RESPONSE TO NRC QUESTIONS
ON PALO VERDE
SEISMIC HAZARD ANALYSIS

Arizona Public Service Company
Phoenix, Arizona

Risk Engineering, Inc.
Golden, Colorado

April 7, 1993

Figure 3-13: Soil amplification, Units 1,2, and 3; PGA

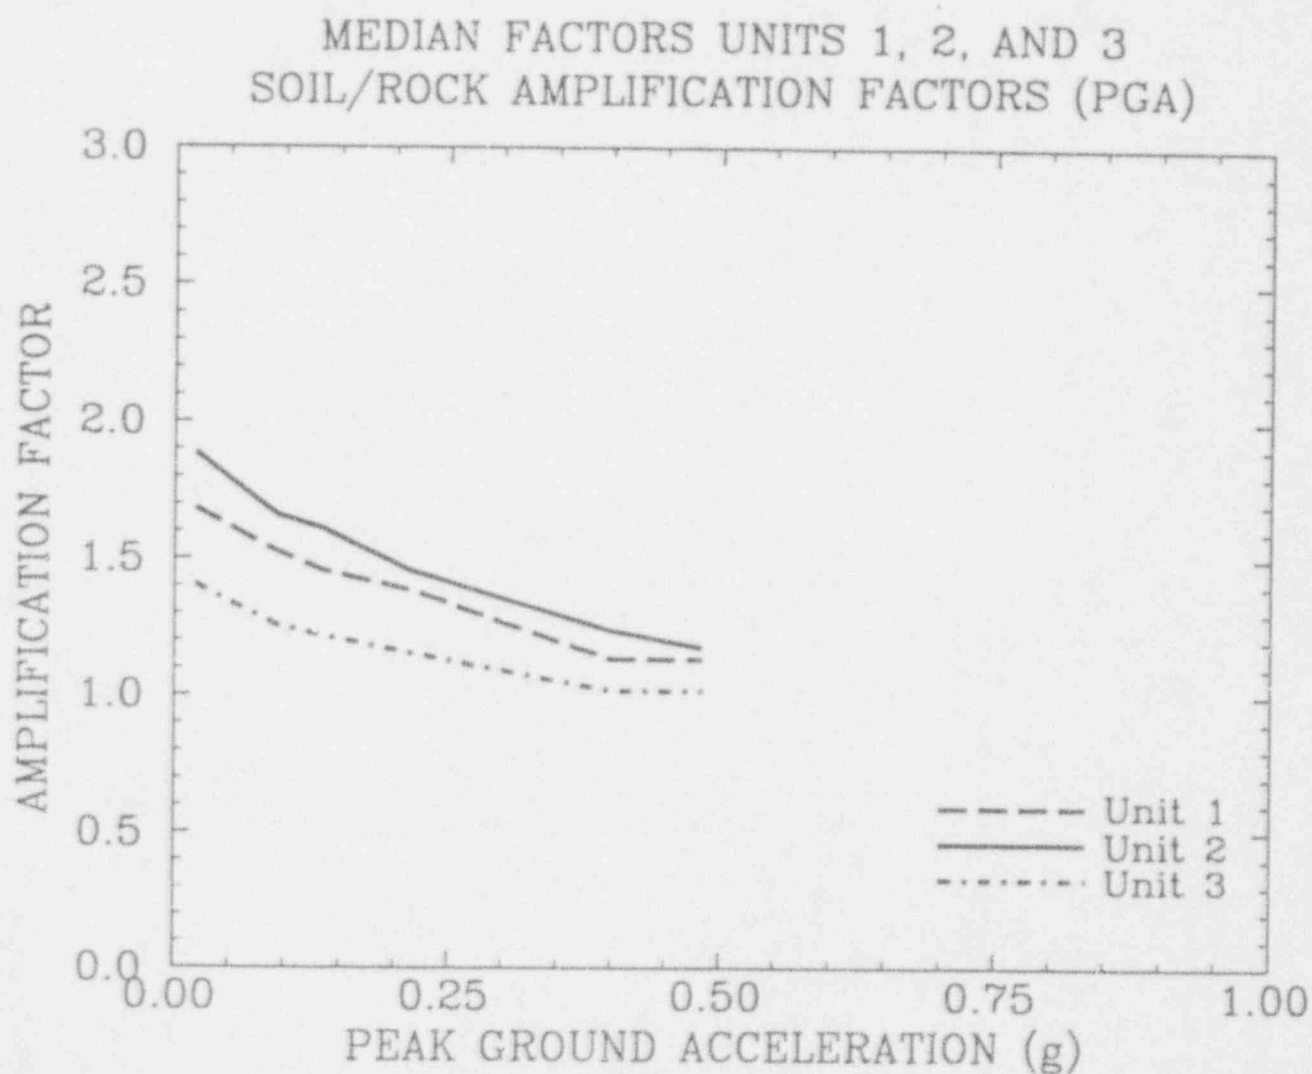
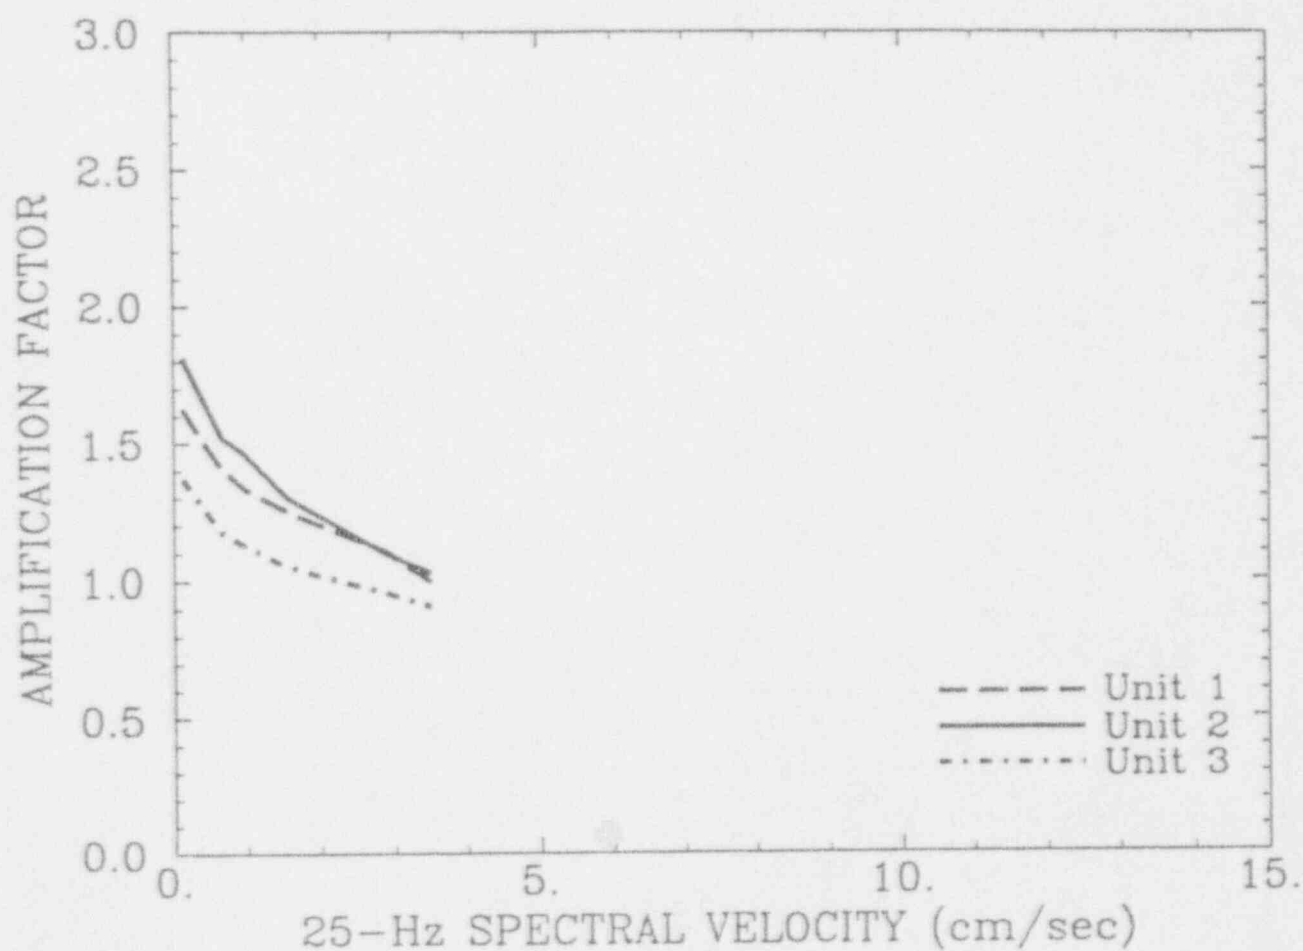
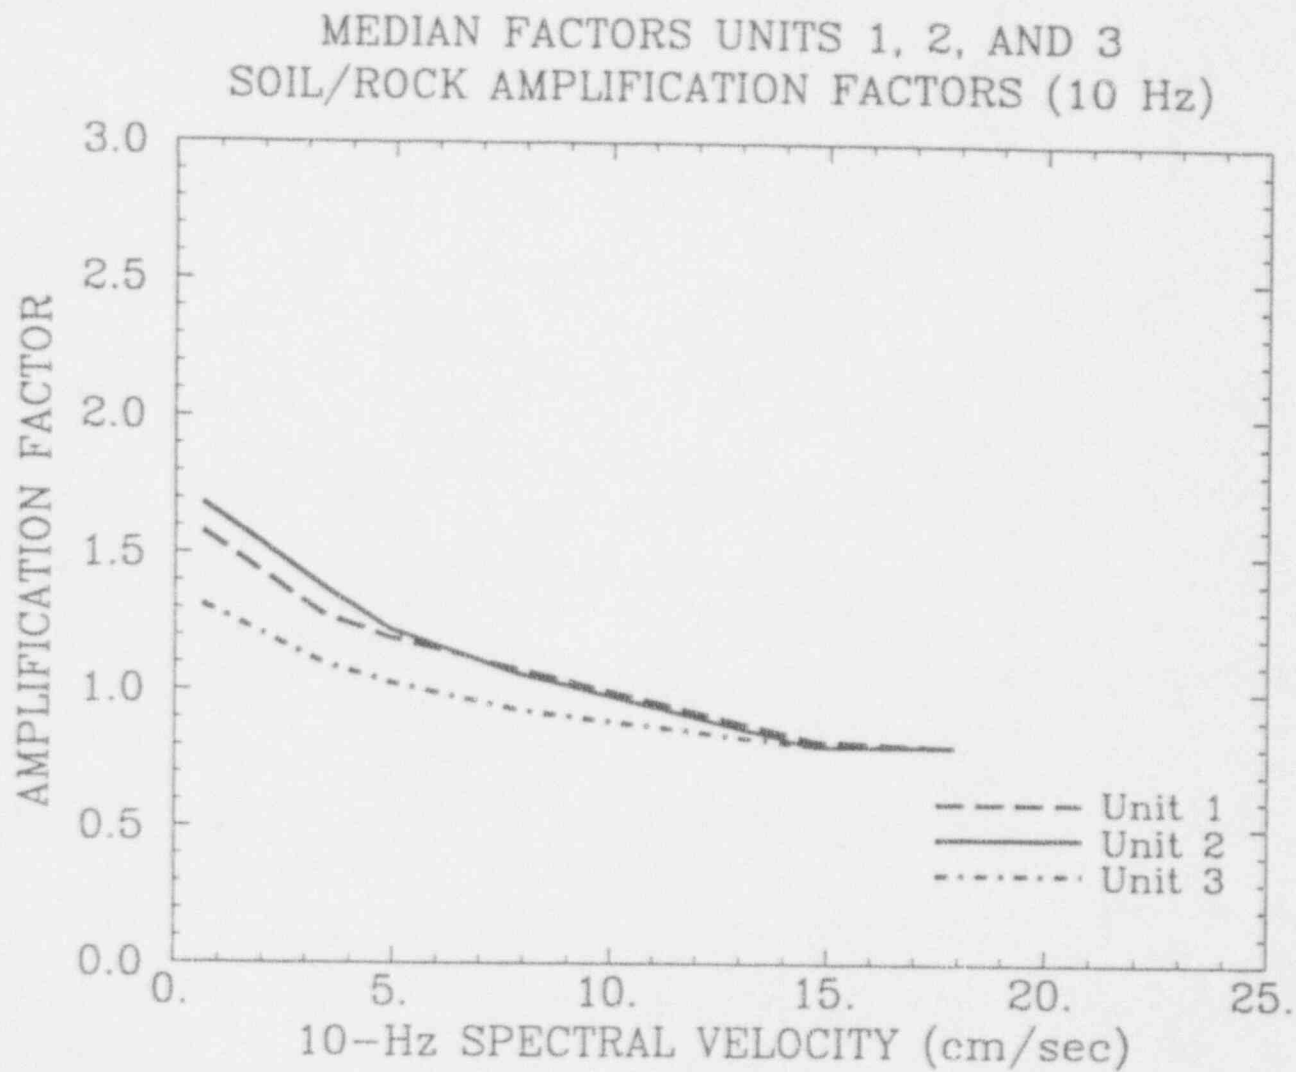
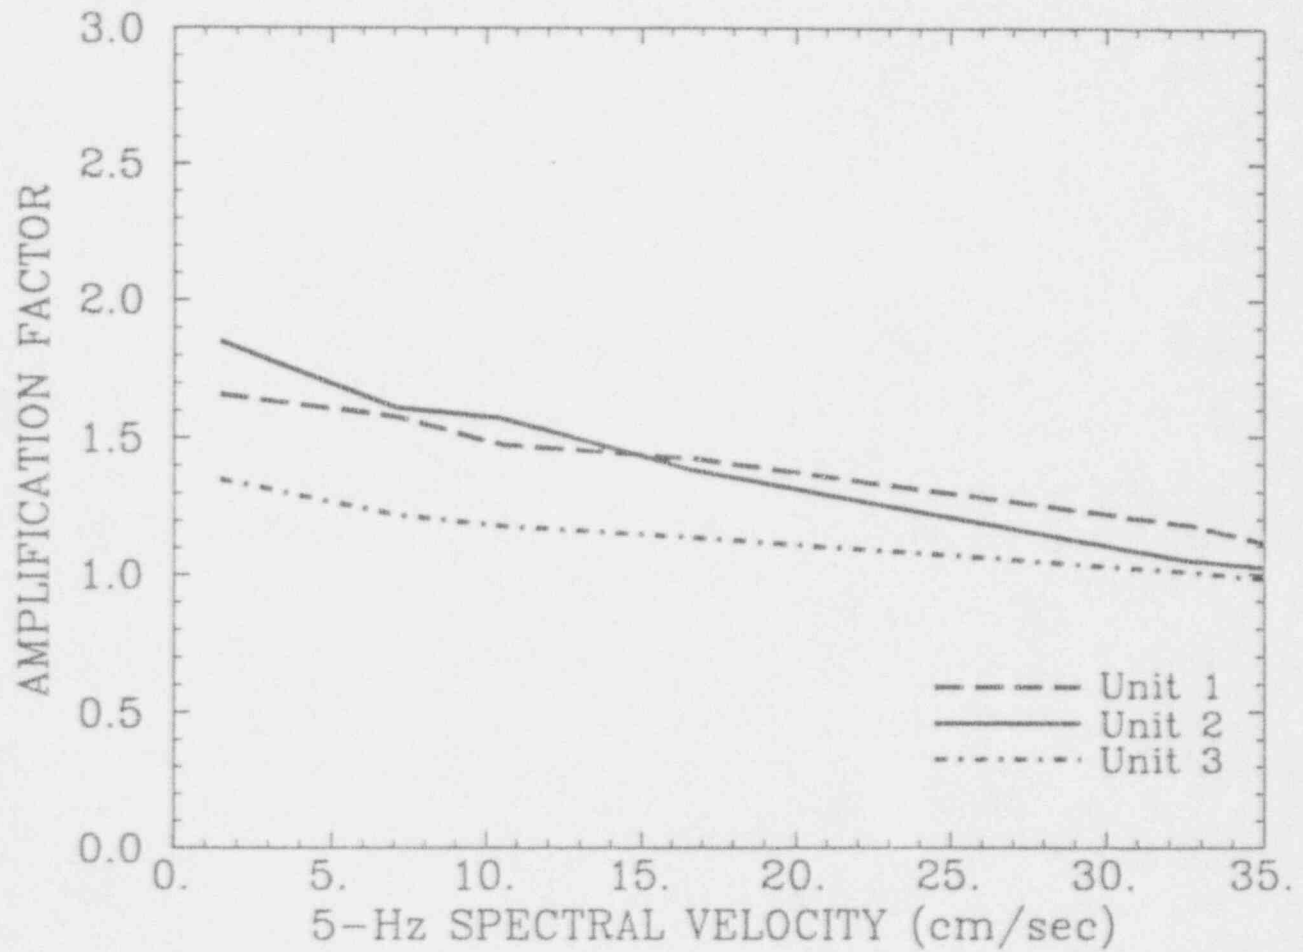
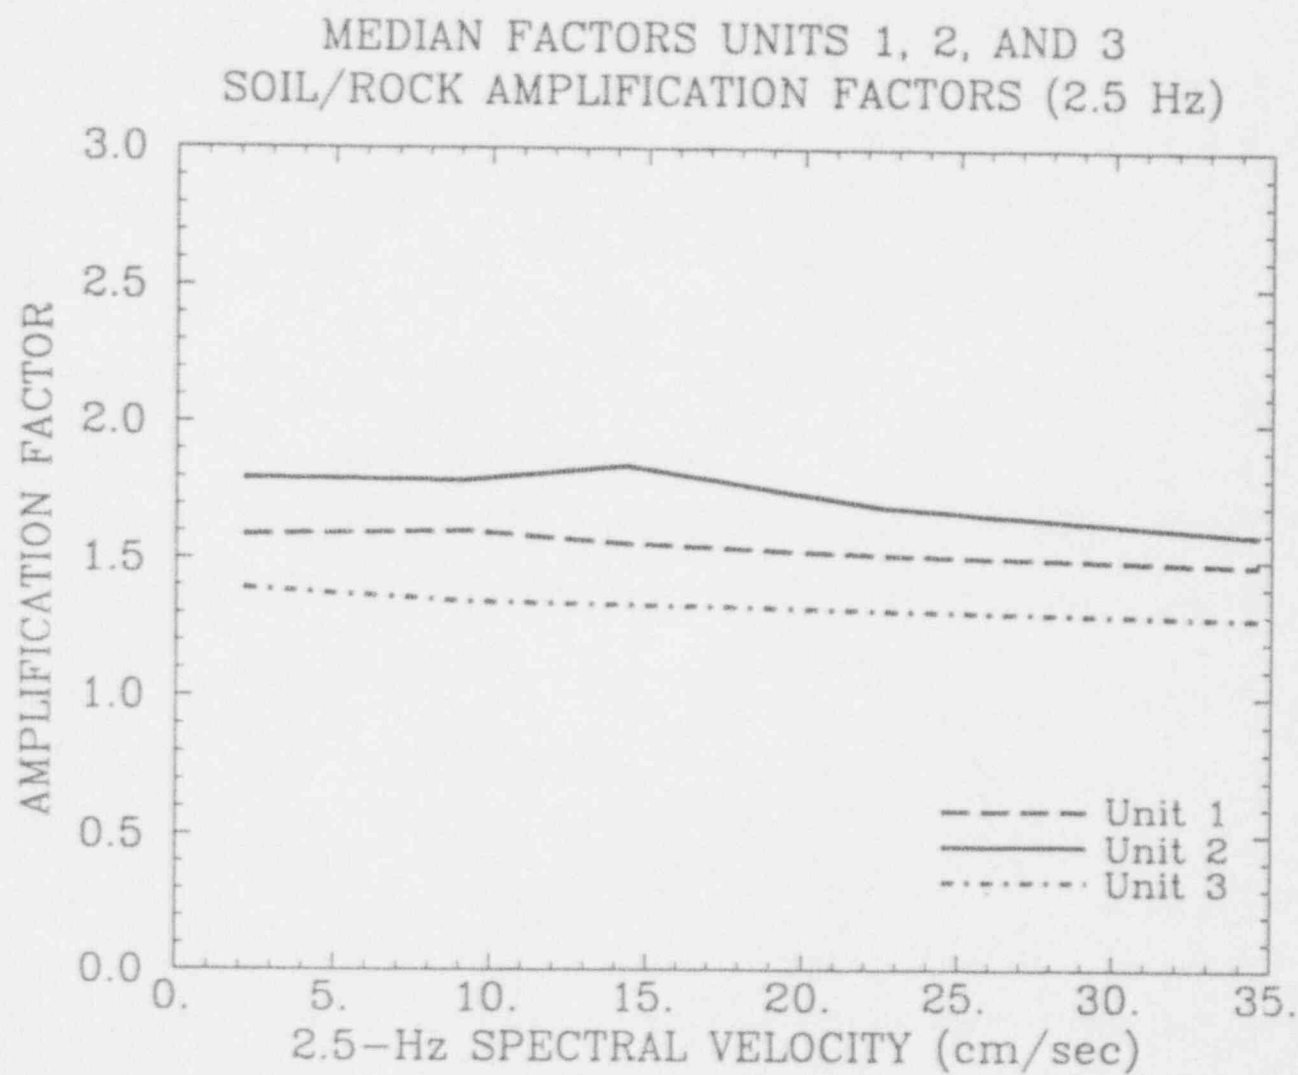
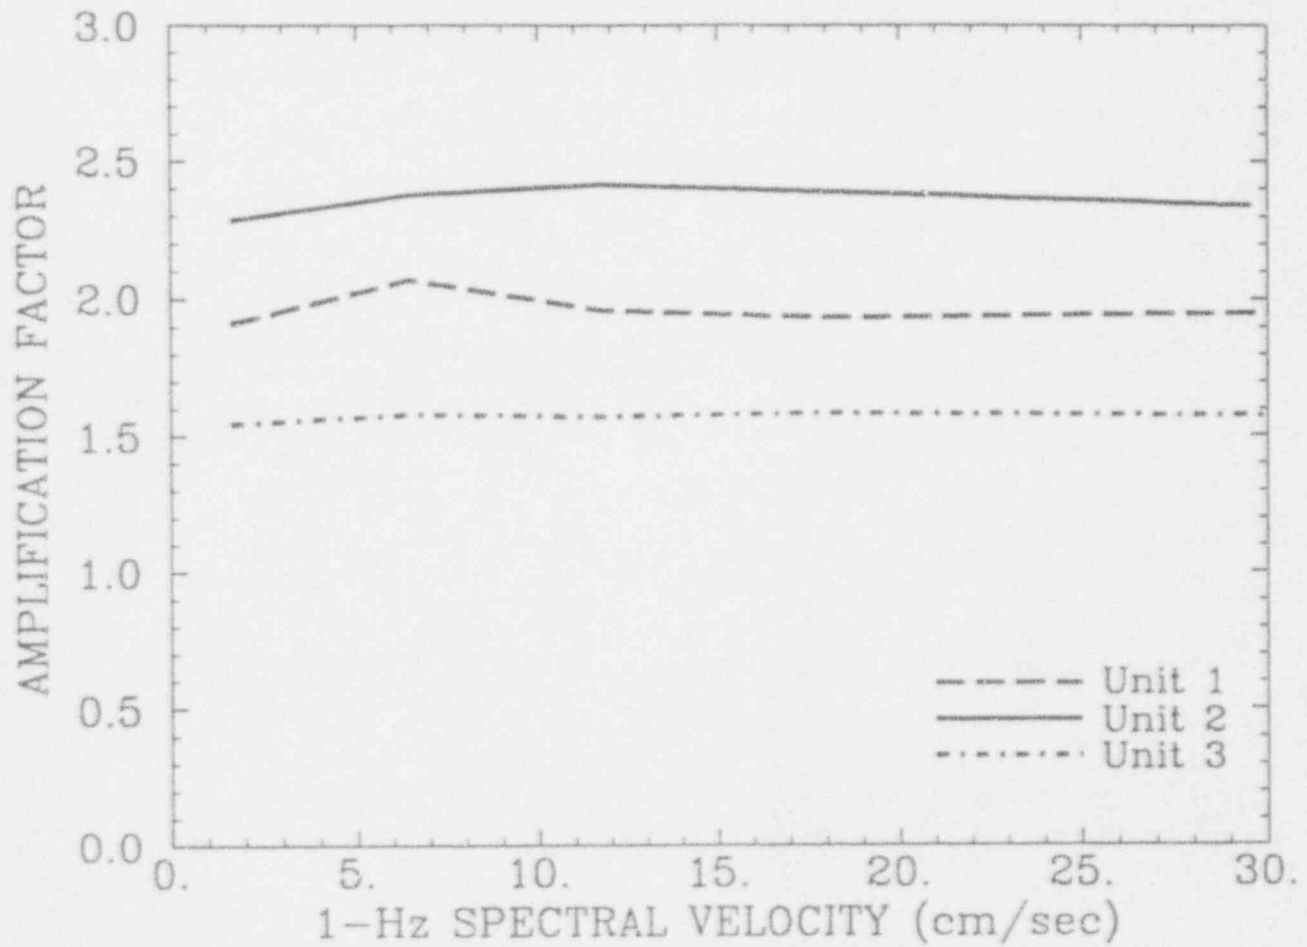
Question II-3 (Soil Characteristics): "The supplemental study (Ref. 3) uses the modulus reduction and damping curves developed by Seed and Idriss and a "Standard Soil Profile." The staff recommends that a sensitivity study be performed using the range of shear degradation models shown in Figure 2 and that it assesses the influence of using the upper range and lower range of the soil profiles shown in the supplemental report (Ref. 3, Supplemental Report, Figure 2-2)."

As a final sensitivity, Figures 3-13 through 3-18 show the soil amplification factors for the three units at Palo Verde. The base case results used only the amplification factors for Unit 2, which are conservative (higher amplification) with respect to application at the other two units.
